FALCON POINTE SUBDIVISION, **RESUBDIVISION OF LOT B**

APPLICATION NUMBER 13 DATE November 7, 2013

DETAIL SITE PLAN

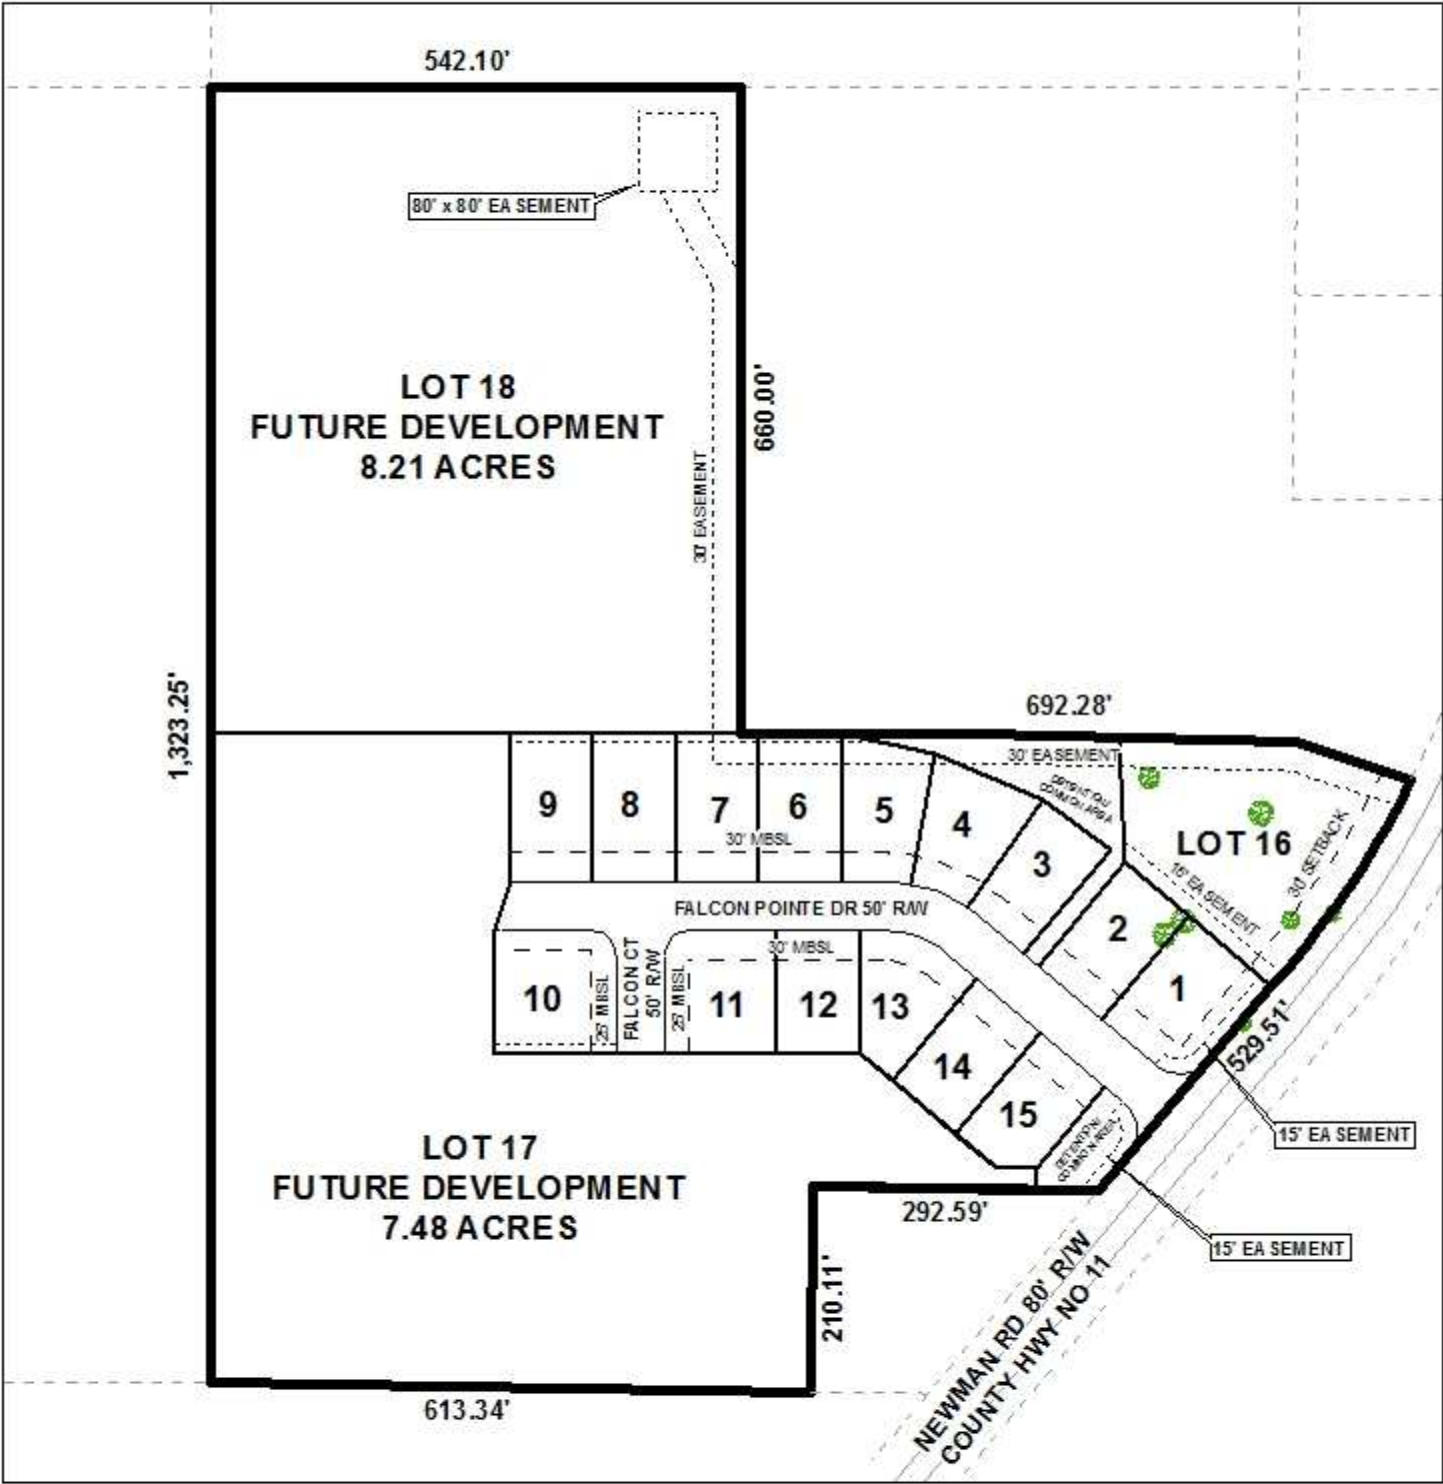
It should be noted that the legal description and acreage information on the preliminary plat describes both Lots A and B and should be revised on the Final Plat to describe only Lot B.

The preliminary plat illustrates the construction of two new streets labeled as Falcon Pointe Drive and Falcon Court. Falcon Pointe Drive terminates as a street stub, as does Falcon Court: this implies future extensions. The proposed Lot 18 is landlocked and as the subdivision is proposed now with no provision of a street stub, the approval of the subdivision may create difficulties accessing the proposed lot because there is no frontage onto a street. If approved, the Final Plat should be revised to combine the proposed Lots 17 and 18 into one lot which is to be labeled as future development. A provision of a (temporary) turnaround in compliance with Sections V.B.6. and V.B.14. of the Subdivision Regulations should also be illustrated on the Final Plat, if required by Mobile County Engineering.

It should be pointed out that the site contains numerous easements which are illustrated on the preliminary plat; however, the southern boundary of the proposed Lot 10 appears to contain an easement, but is not labeled as such. Similarly, the northeast corner of the proposed Lot 18 also appears to contain additional easements which are not labeled. If approved, the Final Plat should be revised to accurately label all easements which are not labeled, retain all illustrated easements, and contain a note stating that no permanent structures can be constructed in any easement.

In accordance with the Subdivision Regulations, a minimum building setback line from all streets is depicted throughout the site; however, it should be noted that for the proposed Lots 1-9 and Lots 11-16, the minimum building setback is 30'. There is a 25' minimum setback for the proposed Lot 10 and the western lot line of the proposed Lot 11. The minimum building setback line for the proposed Lot 17 should be illustrated around the required turnaround at the terminus of both Falcon Pointe Drive and Falcon Court on the Final Plat, if approved. The lot size in square feet and acres is illustrated on the preliminary plat and should also be retained on the Final Plat, if approved.

As a means of access management, a note should be placed on the Final Plat limiting all proposed lots to one curb-cut, with the size, design and location to be approved by Mobile County Engineering and conform to AASHTO standards. A note should also be placed on the Final Plat stating that Lot 1 is denied direct access to Newman Road.

GIS data indicates the presence of wetlands on the western portion of the proposed Lot 18. The existence of wetlands would indicate that the area may be environmentally sensitive; therefore, if approved, any development of the site must comply with local, state and federal regulations regarding wetlands. A note regarding this requirement should appear on the Final Plat, if approved.

- 1) Revision of the legal description and acreage on the Final Plat to only describe Lot B;

- 2) Revision of the Final Plat to combine Lots 17 and 18 and label the area as future development;
- 3) Provision of a turnaround illustrated on the Final Plat in compliance with Sections V.B.6. and V.B.14. of the Subdivision Regulations, if required by Mobile County Engineering;

- 4) Revision of the Final Plat to accurately label all easements which are not labeled and retain all other illustrated easements;
- 5) Placement of a note on the Final Plat stating: *(All proposed roadways to be built to City of Mobile standards and be accepted by Mobile County prior to the signing of the Final Plat.);*

- 6) Placement of a note on the Final Plat stating: *(No permanent structures shall be constructed in any easement.);*
- 7) Placement of a note on the Final Plat limiting all proposed lots to one curb-cut, with the size, design and location to be approved by Mobile County Engineering and conform to AASHTO standards;

- 8) Placement of a note on the Final Plat denying Lot 1 direct access to Newman Road;
- 9) Placement of notes on the Final Plat stating: *(Any development of the site must comply with local, state and federal regulations regarding wetlands.);*
